**Our Case Number:** ABP-316272-23

**Re:** Bus Connects Templeogue/Rathfarnham to City Centre Core Bus Corridor Scheme  
Templeogue/Rathfarnham to City Centre

**BusConnects Templeogue / Rathfarnham to City Centre CBC  
Rathfarnham Castle Park Woodland Playground  
Importance to the Autistic Community**

**BusConnects Dublin Templeogue / Rathfarnham to City Centre CBC  
Submission on Planning Application in relation to the Proposed Scheme  
Objection to proposed Compulsory Purchase Orders  
Rathfarnham Castle Park  
Entrance to Rathfarnham Wood Estate**

**Fig 14.5 – Regional Aquifers:**

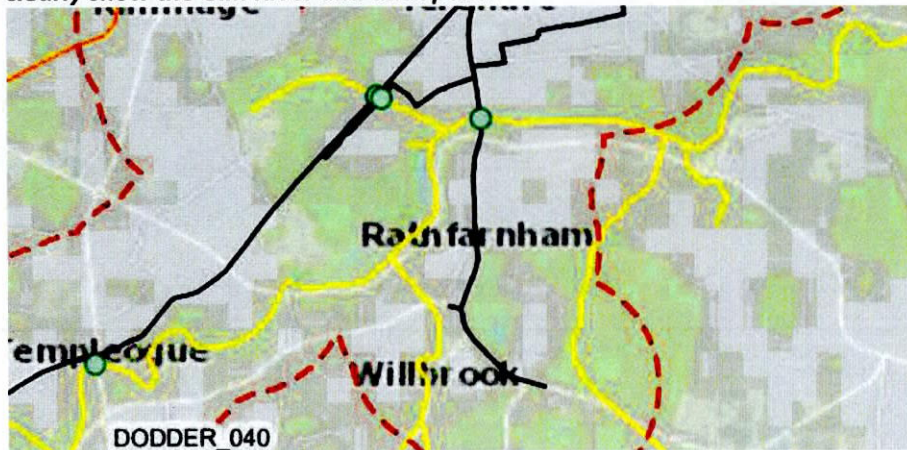
Similarly, in **Fig 14.13 – Aquifers**, the watercourse and pond (shown in outline) and where it runs under Grange Road in two separate locations, and would therefore be built directly over, can clearly be seen:

Yet when it comes to the actual environmental study areas, the Glin River and duck pond are not included. They have clearly not been evaluated or even considered. We cannot understand this glaring omission and clear breach of the Water Framework Directive.

**Image 2.14 from Chapter 2 of the EIAR showing minimal impact from Grange Road to Rathfarnham Road / Fergus Road:**

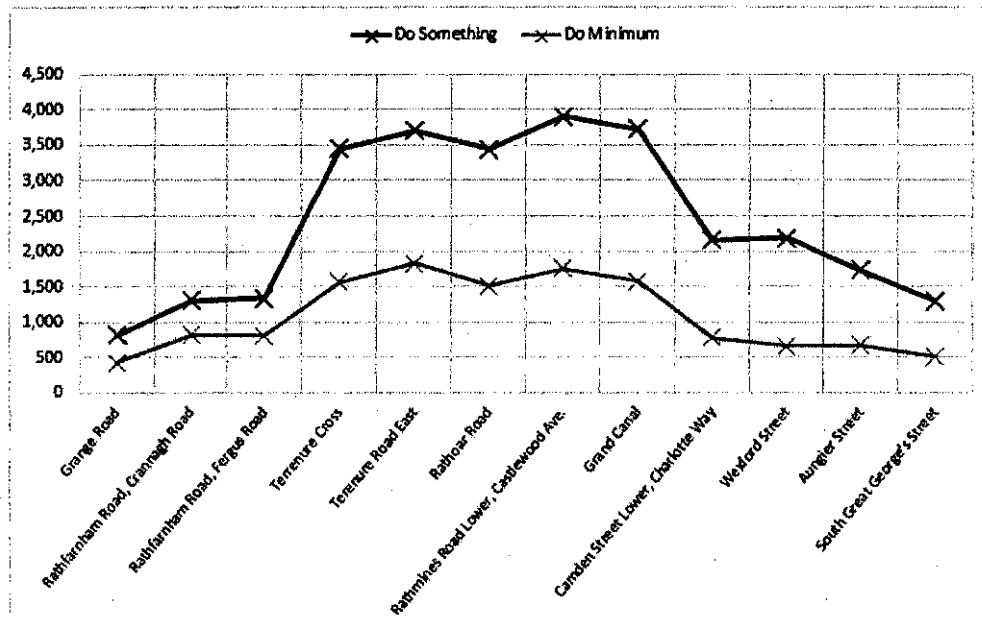
The projections show that the proposed reductions in journey time due to BusConnects will be minimal. Image 2.14 in Chapter 2 of the EIAR shows that the BusConnects scheme would have a far lesser impact around Rathfarnham than it would at other areas in any event.

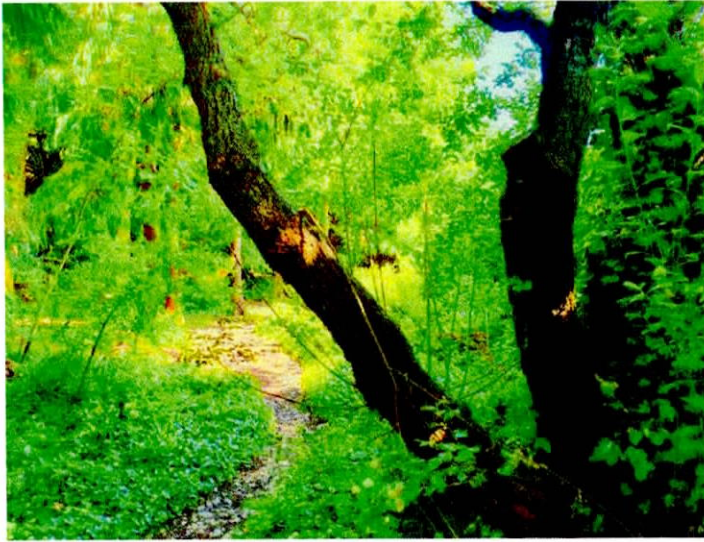
10.4.4.1.1. states that: *“The following amenity designations are also expected to experience the following a Negative, Significant and Short-Term impact during the Operational Phase of the Proposed Scheme:*

This is simply wrong - the impact on Rathfarnham Castle Demesne’s Woodland area will not be short term.

**Fig 12.1.3. - Ecological Study Areas: Aquatic and Riparian Survey Site:**

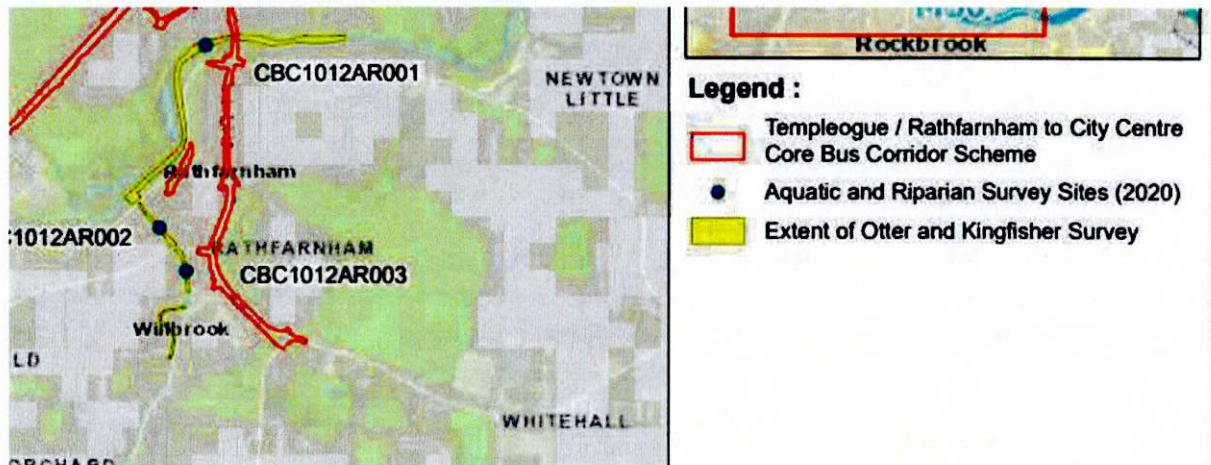
It is clear that neither the Glin River nor the pond were surveyed for otters or kingfishers. This is despite the fact that a kingfisher has been spotted in the Park, most recently on 23/7/23 and the Glin River / Whitechurch Stream is a known otter habitat.

**Fig 14.5 – Regional Aquifers - Again, the River Glin and pond can clearly be seen in this extract from Fig 14.5:**

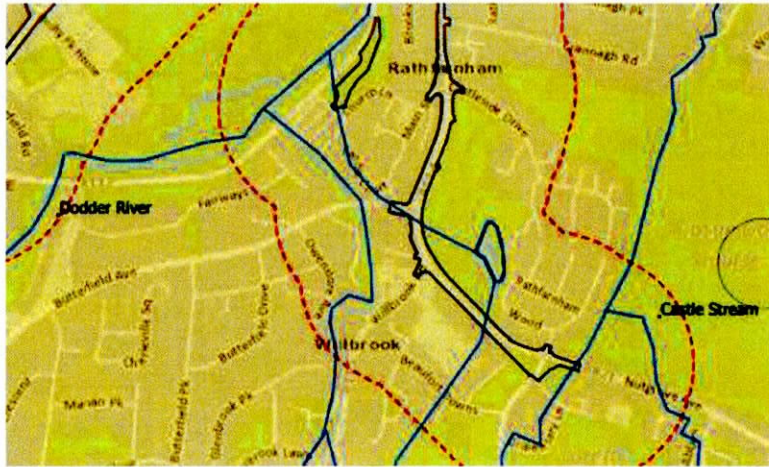
In any event, as stated already, the River Glin and RCP pond are actually already clearly shown in **Fig 14.5 – Regional Aquifers** – yet they were not taken into account for the purposes of hydrological, hydrogeological or other environmental assessments.

**Fig 12.1.2 Ecological Study Areas: Wintering Bird Transect Route – RCP was not studied:**

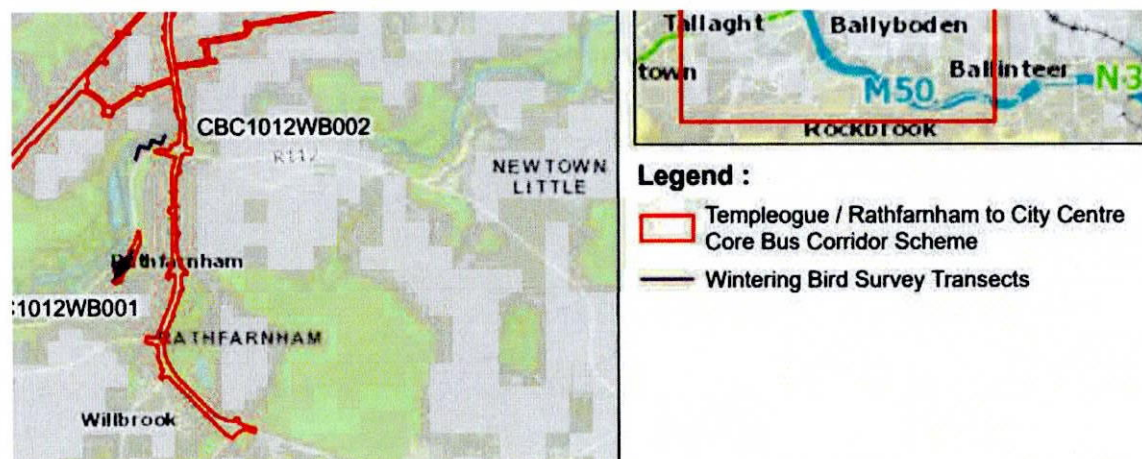
This omission can also be seen from Fig 12.1.2 Ecological Study Areas: Wintering Bird Transect Route - the wintering bird survey transects did not include RCP.

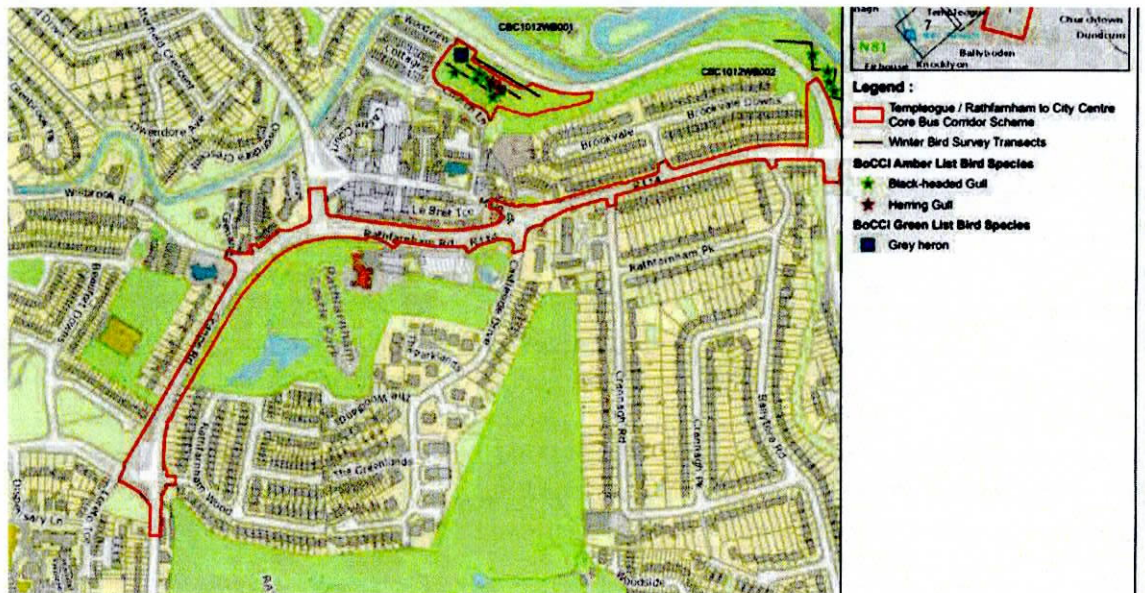
**Fig 12.8 Wintering Bird Survey Results** – we have regular sightings of black headed gulls and a grey heron in RCP, as can be seen from our photos. There were only a few sightings in the area. However RCP wasn't surveyed for wintering birds, as shown above.
